Access Compliance Report

Public Rights-of-Way

(Curb Ramps)

Intersection ID: 16237	Main Street: ELLENWOOD_PL	Cross Street: FREELAND_LN	Location: NE
ADA ID: CC17184A8353	Ramp Type: PerpDiag	Initial Pass/Fail: Fail	Overall Compliance: No
		Severity Score: 8.75

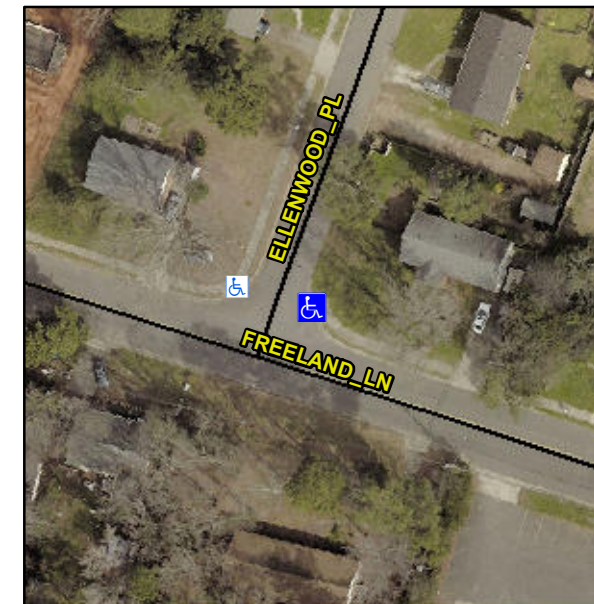
Not Found, R304.5.1

Compliance	Description	Data	Compliance	Description	Data
N/A	Ramp Length (in)	94.0	Yes	Ramp Slope (%)	6.5
No	Ramp Width (in)	47.0	Yes	Ramp XSlope (%)	0.6
N/A	Flare Type LT	N/A	N/A	Flare Type RT	N/A
N/A	Flare Slope LT (%)	N/A	N/A	Flare Slope RT (%)	N/A
N/A	Flare Traversable LT?	N/A	N/A	Flare Traversable RT?	N/A
N/A	Landing Length (in)	N/A	N/A	DWS Provided?	N/A
N/A	Landing Width (in)	N/A	N/A	DWS Contrast?	N/A
N/A	Landing Slope (%)	N/A	N/A	DWS Length (in)	N/A
N/A	Landing X Slope (%)	N/A	N/A	DWS Full Width?	N/A
N/A	Landing Curb? (Y/N)	N/A	N/A	DWS Offset (in)	N/A
N/A	Shared Landing?	N/A			
N/A	Gutter Ponding?	N/A	N/A	Gutter Slope (%)	N/A
N/A	Gutter Lip Ht (in)	N/A	N/A	Gutter X Slope (%)	N/A
N/A	Painted X Walk1?	No	N/A	Painted X Walk2?	No
	X Walk 1 Direction	To NW		X Walk 2 Direction	To SW
N/A	X Walk 1 Width (in)	N/A	N/A	X Walk 2 Width (in)	N/A
	X Walk 1 Slope (%)	2.6		X Walk 2 Slope (%)	3.2
	X Walk 1 X Slope (%)	1.4		X Walk 2 X Slope (%)	2.3

Remove & Replace Curb Ramp With Two New Directional Ramps or Equivalent.
